CITY OF ALBUQUERQUE

Planning Department
David Campbell, Director

**RE: Lot 14 Block 6, Volcano Cliffs Unit 9, SAD 228 Unit 22
6212 Camino Alto NW
Grading and Drainage Plan
Engineers Stamp Date 1/5/18 (D10D003B14)**

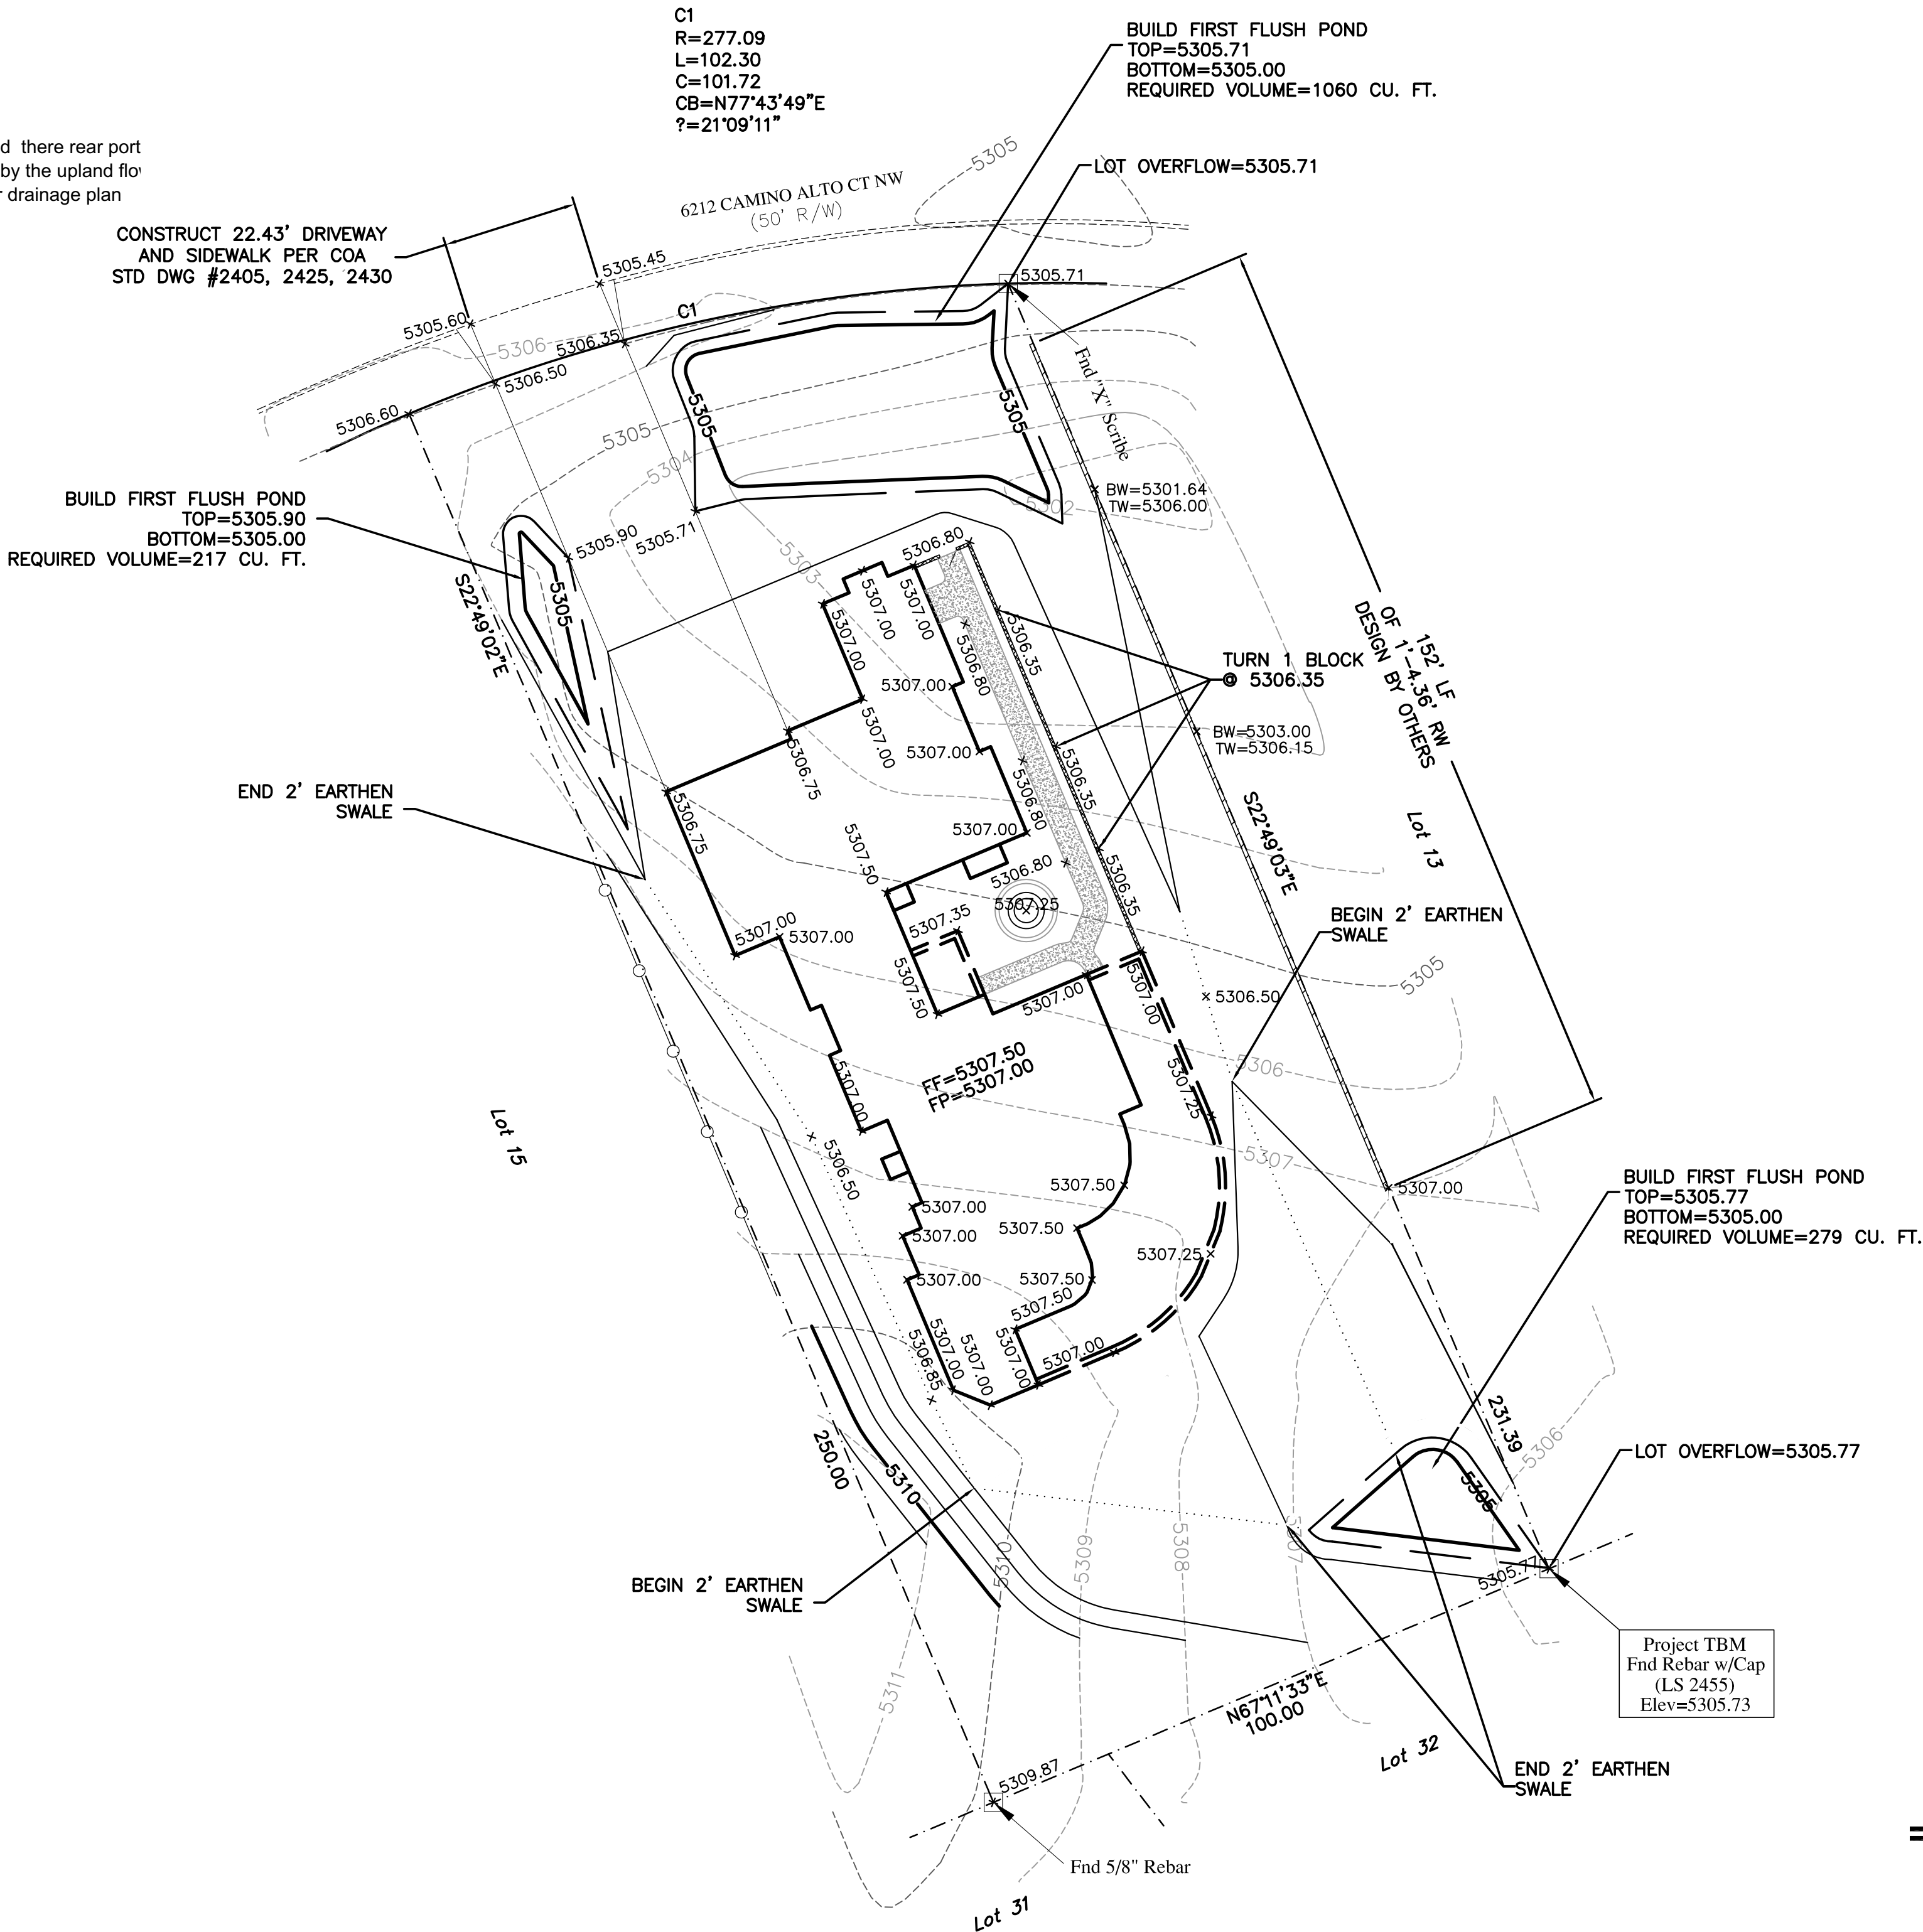
Based upon the information provided in your submittal received 1/8/18, this plan is approved for Grading Permit.

Prior to Building permit approval a Pad Certification will be required, provided by the Engineer or a registered Land Surveyor.

Reiterate to the Owner/Contractor that a separate permit for a garden/retaining wall must be obtained with the approved G&D plan and Pad Certification.

Prior to Certificate of Occupancy release, Engineer Certification per the DPM checklist is required.
